ADDENDUM NO. 2

DATE: January 24, 2025
PROJECT: RRWTP Ion Exchange Improvements
OWNER: Warren County Water and Sewer Department
ENGINEER: AECOM
TO: Prospective Bidders
BIDS CLOSE: February 13, 2025 at 2:00 p.m., eastern standard time.
The bid opening date has been extended as indicated in the changes to specifications as part of this addendum.

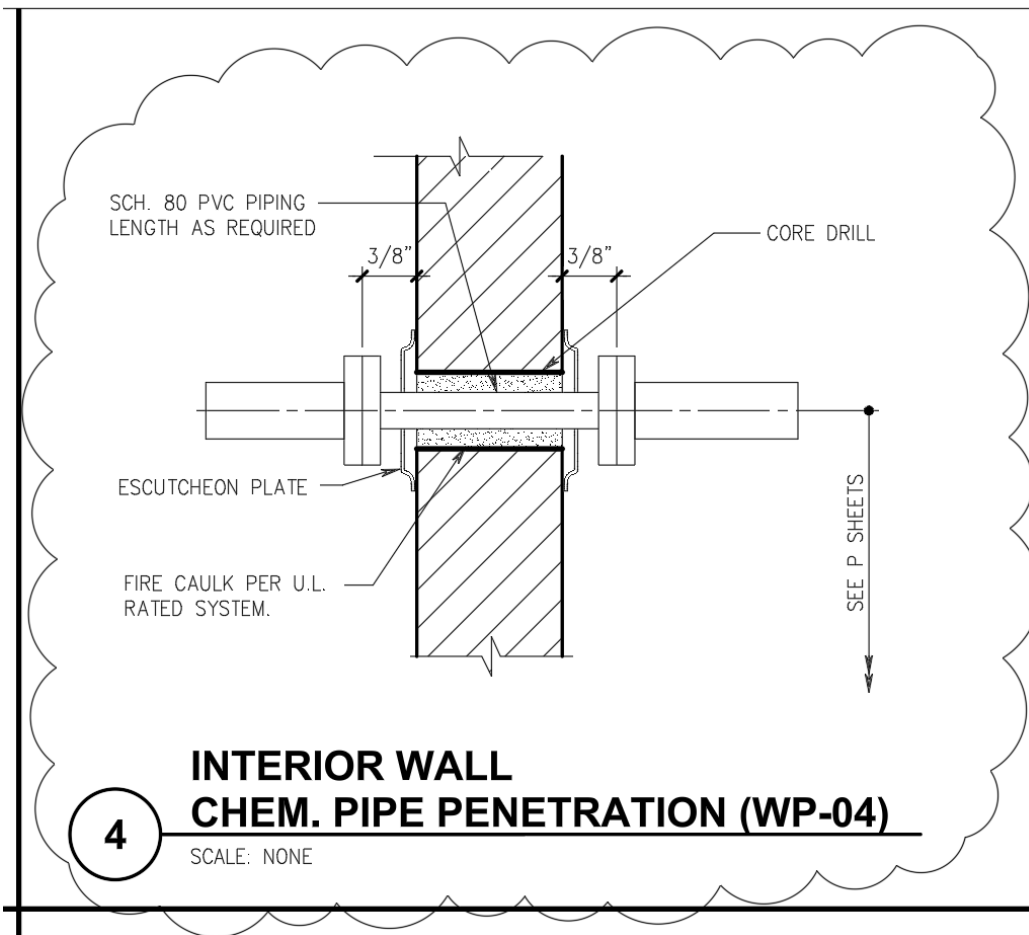
Q: The Sodium Bisulfite Proposed Plan on sheet 1P-09 shows the existing and new lines as being tubing. Also, GP-07 provides detail 4 as being the penetration through the interior wall. However, based on photos w took, the existing chemical piping is Sch. 80 PVC. Please confirm the new Bisulfite piping is to be Sch. 80 PVC and provide a penetration detail for passing through the existing block wall as well as the 12" thick concrete floor at EL. 763.00.

- I. Sheet GP-07: Detail 4, delete the tubing shown passing through the schedule 80 PVC pipe. The updated detail is shown below.

A: Existing lines are ½" schedule 80 PVC piping. Detail 4 on sheet GP-07 has been reissued as part of this addendum to remove the tubing shown inside of the schedule 80 PVC piping. This detail should be used for penetrations through existing block walls. Detail 3 on sheet GP-07 shall be used for floor penetrations through existing concrete floors.

1P-04

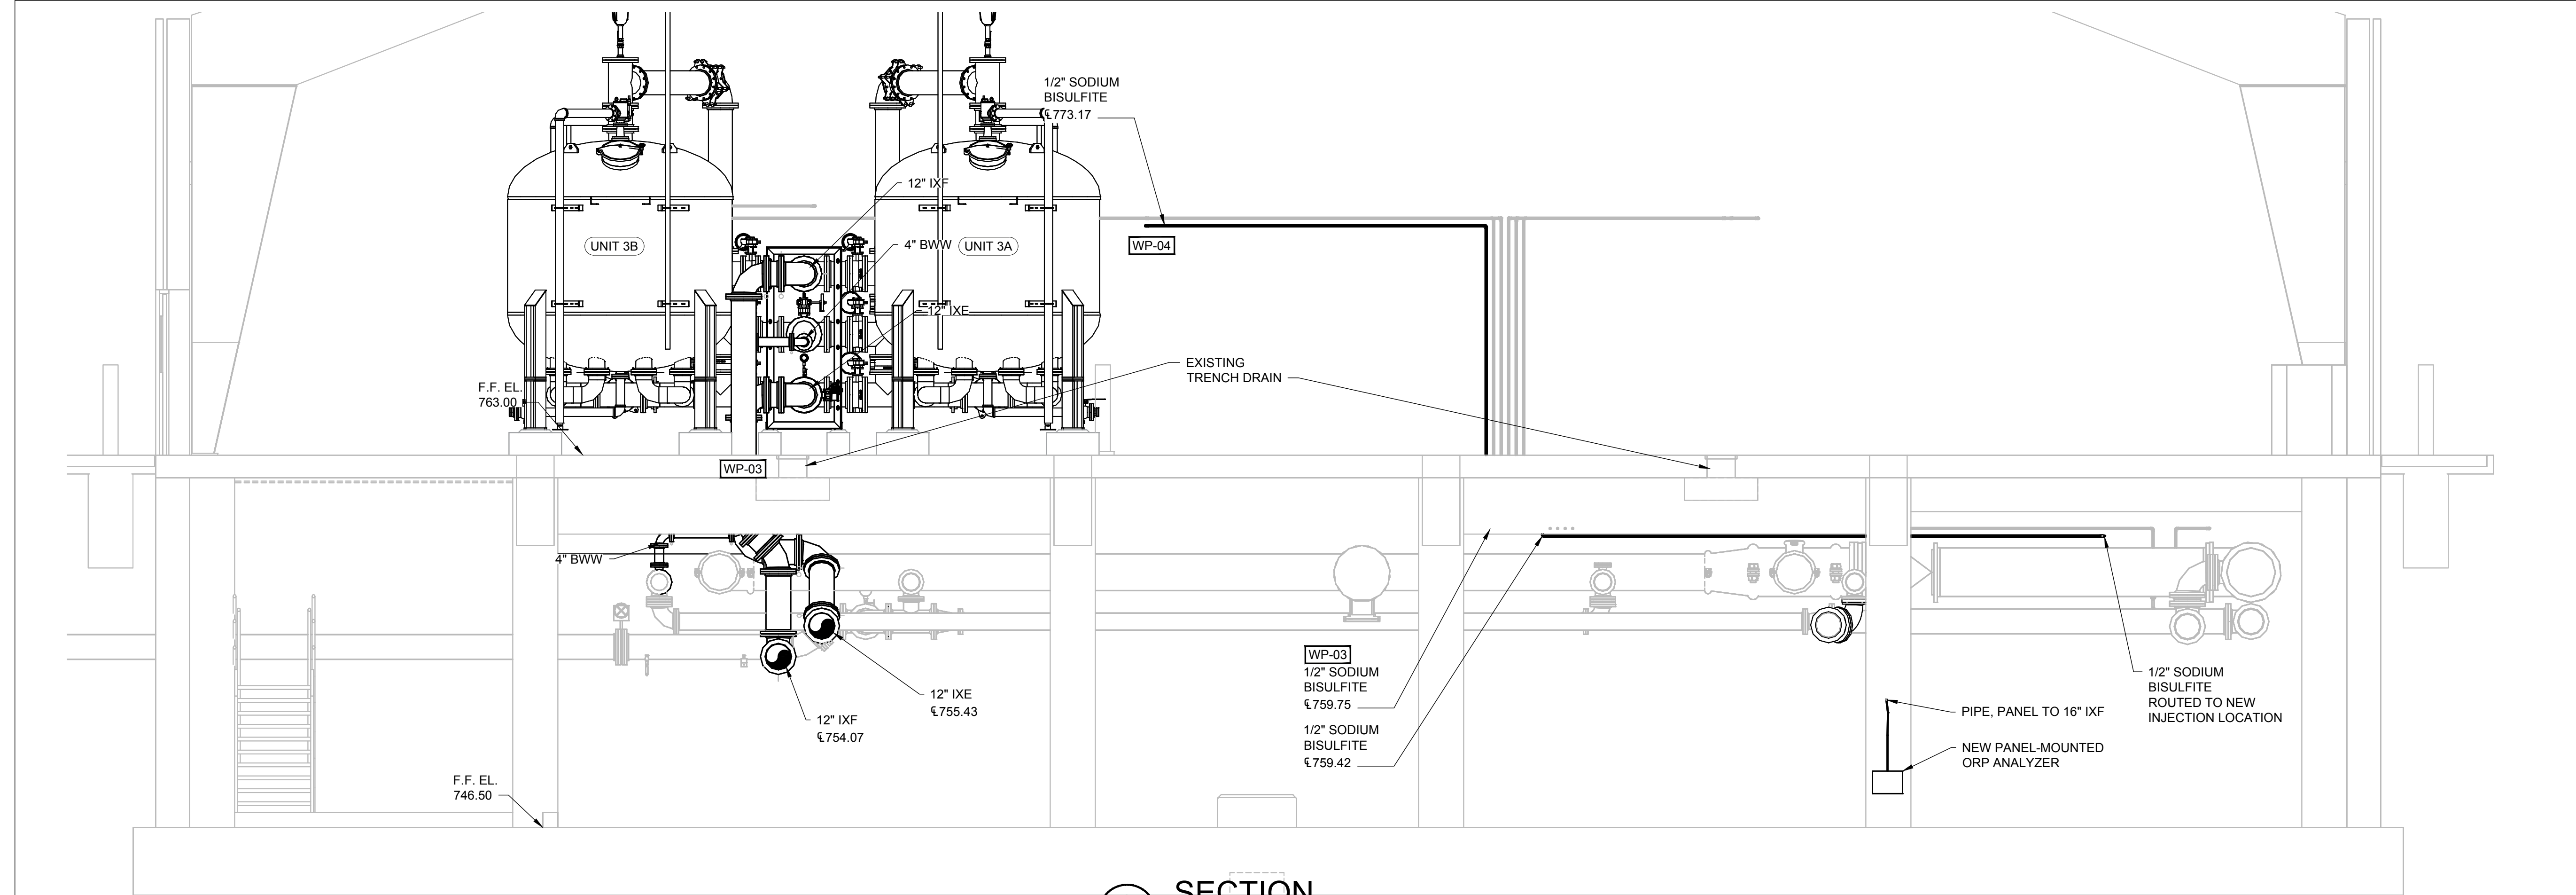
- II. Sheet 1P-04: This sheet has been reissued as part of this addendum to correct a drafting error showing pipe work in Section B that does not exist.
- III. Sheet 1P-09: Replace references to "TUBING" with "SCH 80 PVC". This sheet has been reissued as part of this addendum.
